REMEDIATION SYSTEM REVIEW REPORT  
WALLY'S OIL  
ROUTE 7, BOX 89  
WILTON, MINNESOTA  
MPCA SITE ID #: LEAK000089

Terracon Project No. 41057007  
February 24, 2006

RE: Remediation System Review Report  
Wally's Oil  
Route 7, Box 89  
Wilton, Minnesota  
MPCA Site ID #: LEAK000089  
Terracon Project No. 41057007

**FIGURE 12**  
WALLY'S OIL CAD REVIEW  
Terracon Project No. 41057007

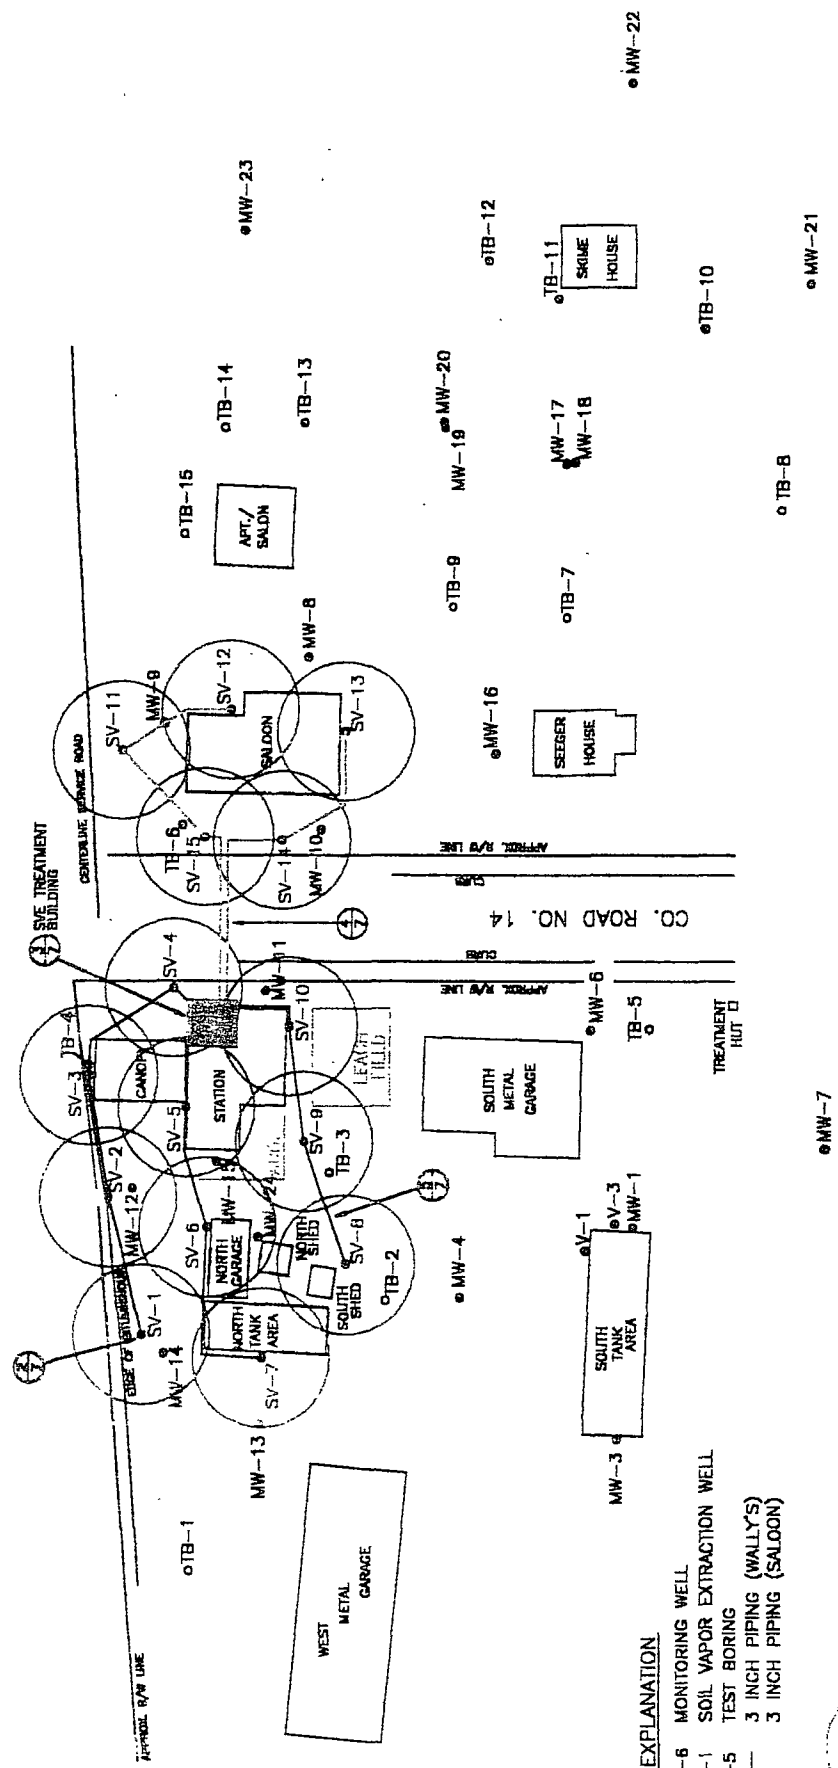
Northern Environmental's CAD indicated ten vent points would be installed at the Wally's Oil property and six vent points would be installed around the periphery of the Wilton Liquor Bar (Figure 11). The radius of influence as depicted on Figure 11 for the vent points is 36 feet. However, the rationale for specifying the radius of influence was not noted. Figures 12 and 13 show configuration of each (Wally's SVE system and Wilton Bar SVE system) SVE system proposed. The construction of the vent points was not fully reported; the screened intervals for the vent wells were not provided.
